Proposal for amendments to

ECE/TRANS/WP.29/2020/81

The text reproduced below was prepared by the experts from the 'task force on testing' lead by JRC/EC. The proposal is aimed at modifying the text of document ECE/TRANS/WP.29/2020/81 (Regulation 157 on ALKS). All modifications to ECE/TRANS/WP.29/2020/81 are given in **blue** text. Deletions are indicated by **red strikethrough** text.

I. Proposal – Annex 5

Figure 10
For $V_{e0} = 130$ kph

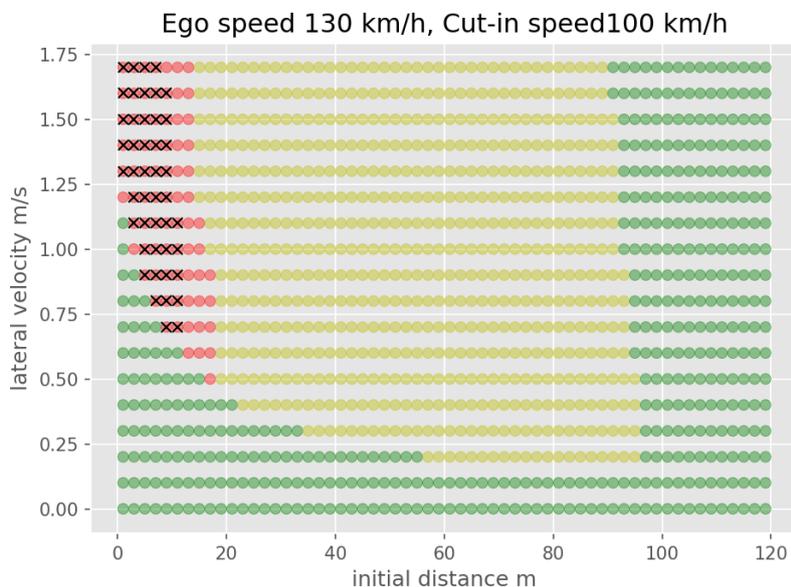
Kommentiert [VS(27)]: KBA: What is the definition of PFS and CFS?

Kommentiert [VS(28R27)]: It is given in the model description.
